Provide Construction Services for Replacement of
Graceland Park/O'Donnell Heights Elementary/Middle School #240 and
Holabird Elementary/Middle School #229
Baltimore City Public Schools (City Schools)

ADDENDUM #3

**GRACELAND PARK/O'DONNELL HEIGHTS ELEMENTARY/MIDDLE SCHOOL #240
BALTIMORE, MARYLAND
ADDENDUM #3**

**HOLABIRD ELEMENTARY/MIDDLE SCHOOL #229
BALTIMORE, MARYLAND
ADDENDUM #3**

1
SK-E-1.15

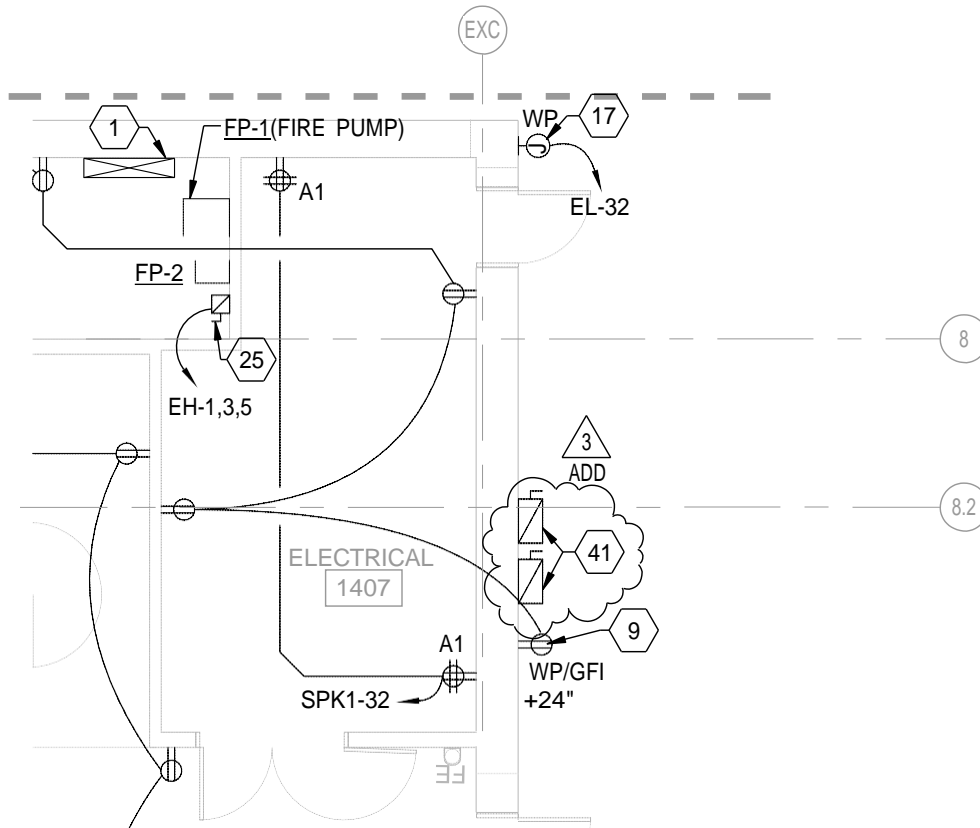
Addendum #1 added two 600 amp fusible disconnect switches to serve the PV Panels at Graceland with Note 42 on Drawing E-2.1G. Two symbols for disconnect switches appear on Drawing E-2.1H for Holabird but have no respective note. Please advise if the disconnect switches added for Holabird on Drawing E-2.1H are also for the PV Panels and should be 600 amp fused at 500 amp similar to Graceland.

REVISE Add Note 41 and Revise drawing in Electrical Room 1407 per attached sketch SK-E-1.15.

The two symbols for disconnect switches on Drawing E-2.1H for Holabird are for the solar disconnects. These disconnects are needed for Utility shutoff. These shall match 600A ampacity/500A fuse size and key note 42 as seen and defined on Graceland Drawing E-2.1G. See attached Sketch SK-E-1.15 for new note 41 and revisions to Room 1407 at Holabird.

41. CONTRACTOR TO PROVIDE AND LOCATE TWO(2) NEMA 3R 600A DISCONNECT SWITCHES WITH 500A FUSE OUTSIDE FOR BALTIMORE GAS AND ELECTRIC PV SHUTOFF. THESE DISCONNECTS WILL SERVE PANELS PV1 AND PV2. PROVIDE SIGNAGE AT THE METER AS REQUIRED TO INDICATE THE LOCATION OF DISCONNECT SWITCHES.
